Addendum Three

The Renovations & Restorations of the Westport Community Center

Issued: Monday, December 19, 2016

M1.11

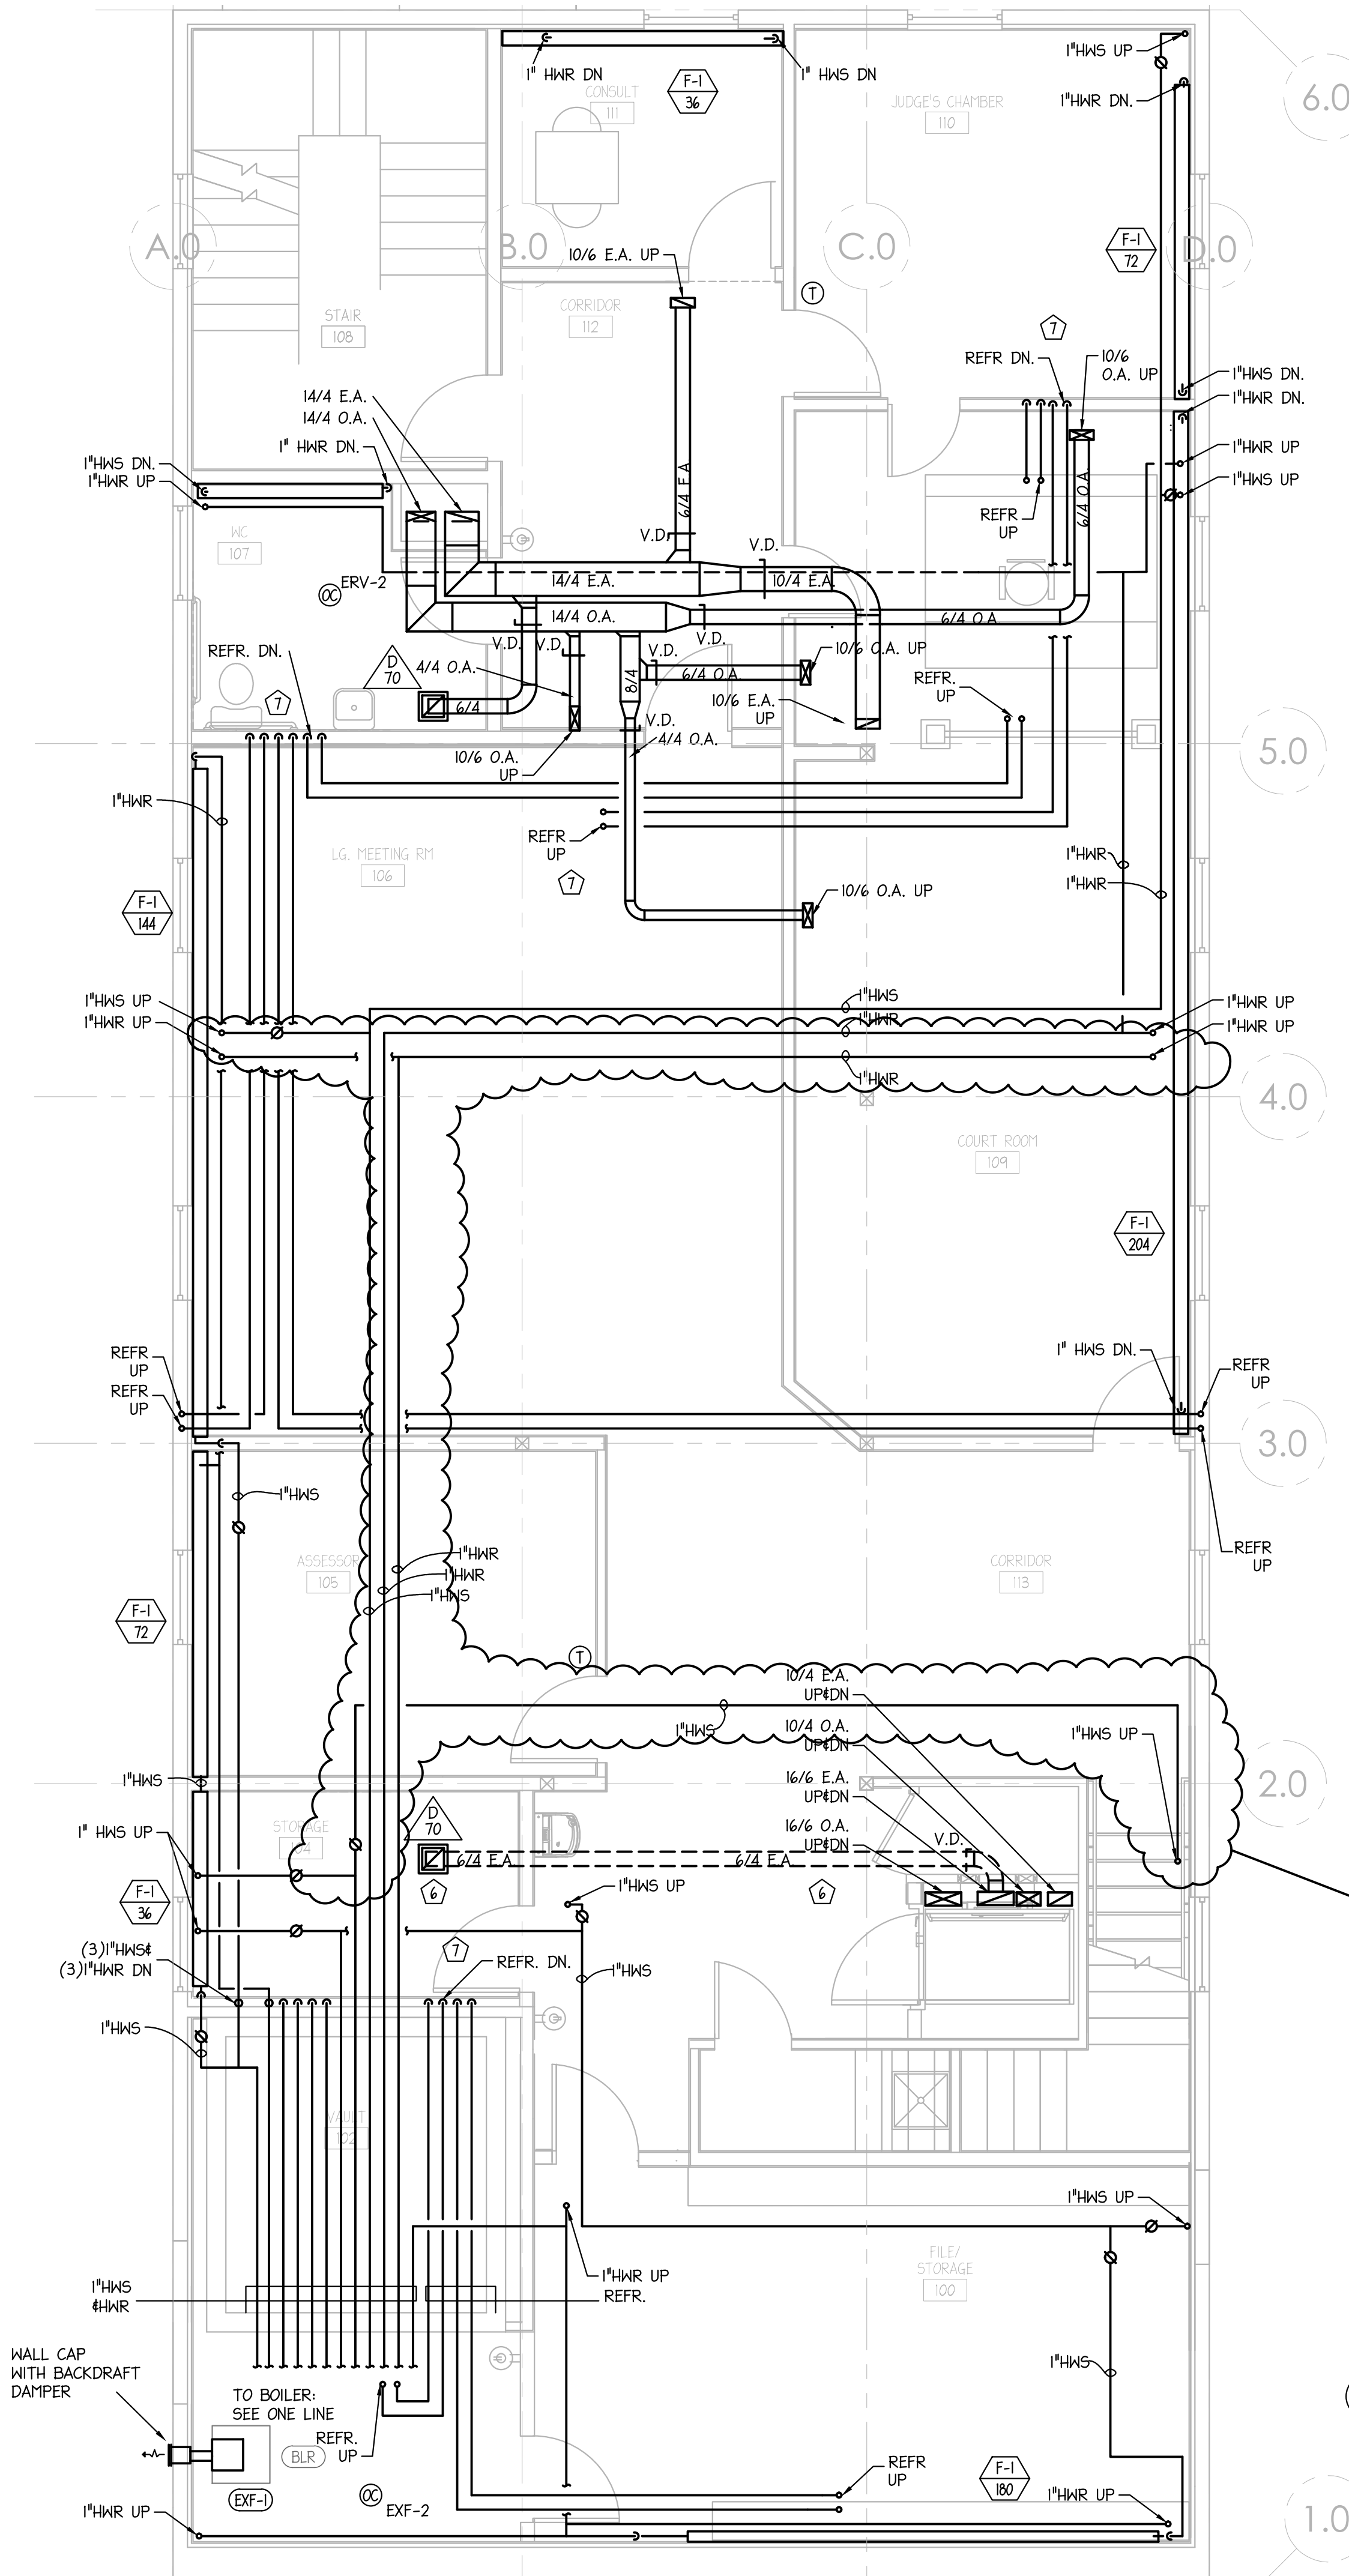
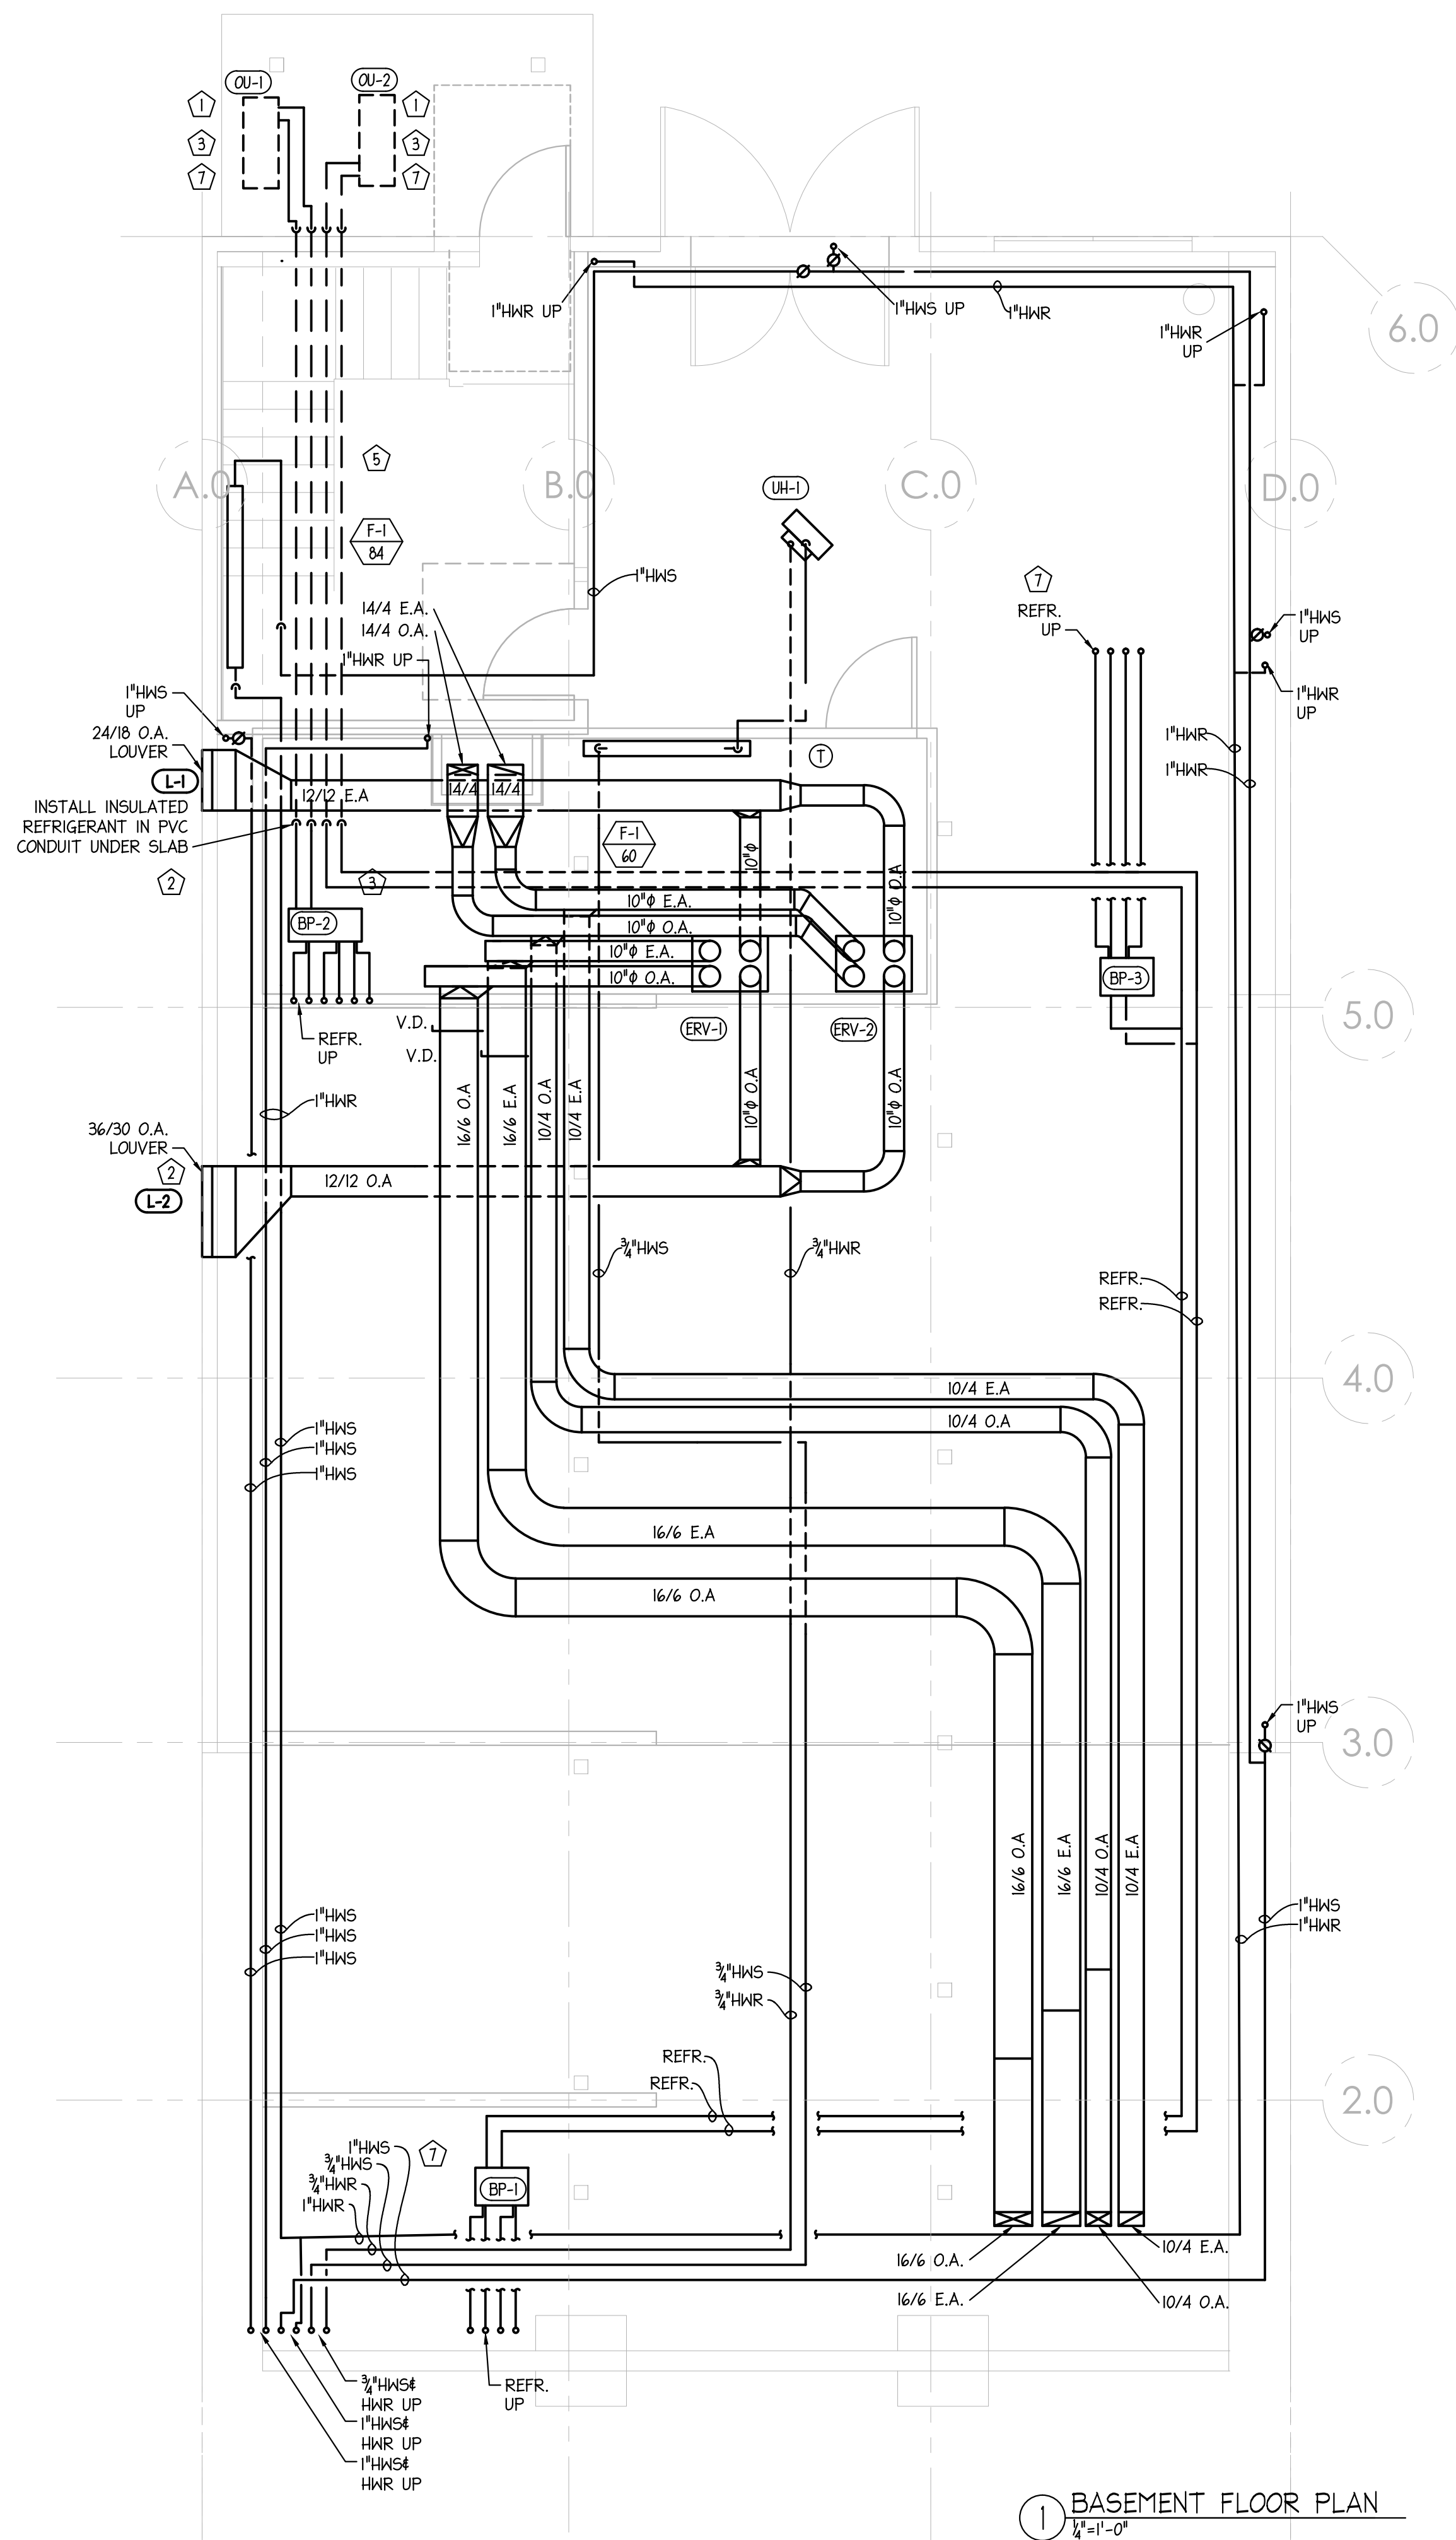
1. What is the condensate pipe material and size?
All condensate piping shown on P1.11 & P1.21 to be ¾" insulated copper or PVC.
2. What is the required duct connection for duct less than 144 sq in? (note 6, M5.01)
3. Which contract is responsible for the condensing units 4" concrete housekeeping pad?
4. Which contact is responsible for the louver wall penetrations?

For Questions 2 – 4 above, please see attached drawings M1.11 and M1.21 for additional notes and clarifications.

- MECHANICAL SPECIFIC NEW WORK NOTES:**
- FURNISH AND INSTALL REMOTE CONDENSING UNIT SPLIT SYSTEM FOR PROPOSED AIR SOURCED HEAT PUMP. REF. PIPE SIZES TO BE COORDINATED WITH EQUIPMENT VENDOR. INSULATE ALL PIPES PER SPECS.
 - FURNISH AND INSTALL NEW WALL PENETRATIONS FOR INTAKE + EXHAUST LOUVERS. COORDINATE WITH STRUCTURAL.
 - THIS WORK SHALL BE INCLUDED AS AN ADD ALTERNATE PRICE ASSOCIATED WITH AIR SOURCED HEAT PUMP.
 - FURNISH AND INSTALL NEW WALL PENETRATIONS FOR EXHAUST FAN. COORDINATE WITH STRUCTURAL.
 - REFRIGERANT PIPING TO BE BURIED UNDER SLAB WITHIN INSULATED PVC CONDUIT.
 - THIS WORK SHALL BE INCLUDED AS AN ADD ALTERNATE PRICE ASSOCIATED WITH WATER CLOSET 104.
 - INSULATED REFRIGERANT PIPING ASSOCIATED WITH AIR SOURCED HEAT PUMP SYSTEM TO BE INCLUDED IN BASE BID TO ALLOW FOR FUTURE INSTALLATION OF HEAT PUMPS.
